**DEPARTMENT OF TRANSPORTATION
STATE OF GEORGIA**

FILE: City of Roswell, Fulton County **OFFICE:** Engineering Services
P.I. No.: 0010874
Big Creek Pkwy, SR140 to East of SR 400 **DATE:** September 9, 2014

SUBJECT: REVERSE RESPONSE TO VE STUDY ALTERNATIVE A-7

Value Engineering Idea No. A-7 – Eliminate buffer strips on bridges.

TYPICAL SECTION #4
 BIG CREEK PARKWAY
 BRIDGE OVER BIG CREEK WATERWAY AND SR 400

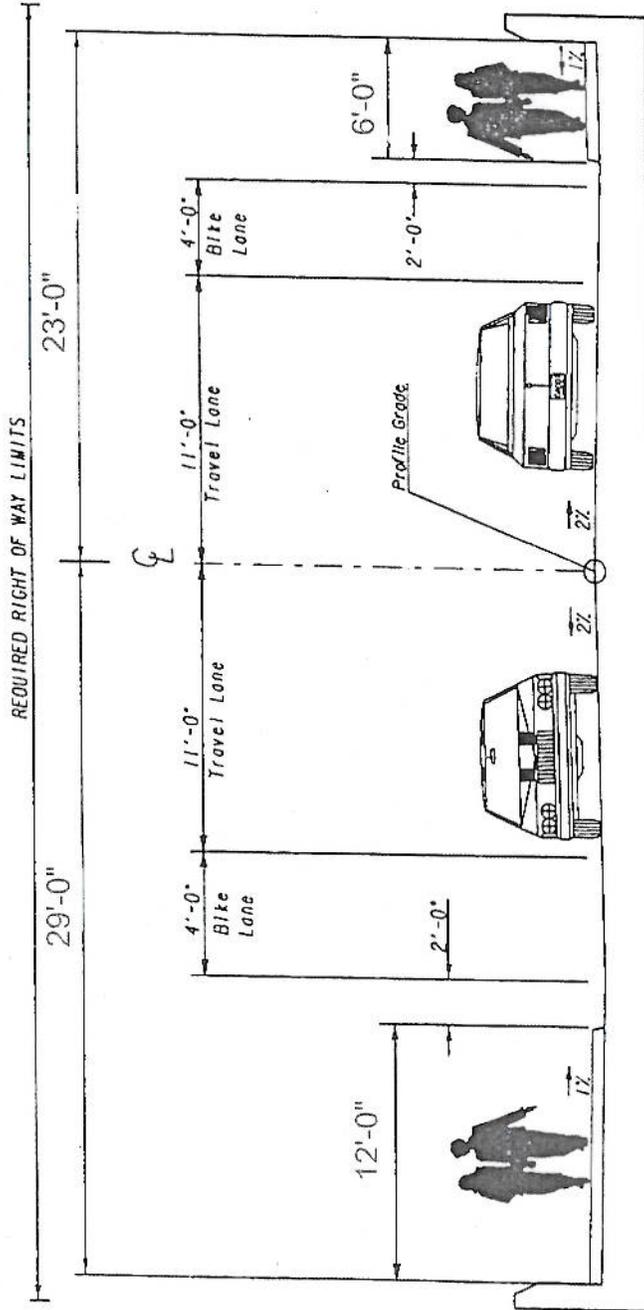
- It is recommended that the bridge cross section be revised as follows: two – 11ft lanes, two – 4ft bike lanes, two – 2ft gutters, one – 12ft multi-use trail and one – 6ft sidewalk. This section is consistent with GDOT Bridge Design Policy, provides some degree of buffer separation for the multi-use trail and leaves room for signage and other fixtures.
- Though the above proposed section varies from that of Value Engineering Idea A-7, the total potential savings of \$1,894,000 and overall widths remain the same.
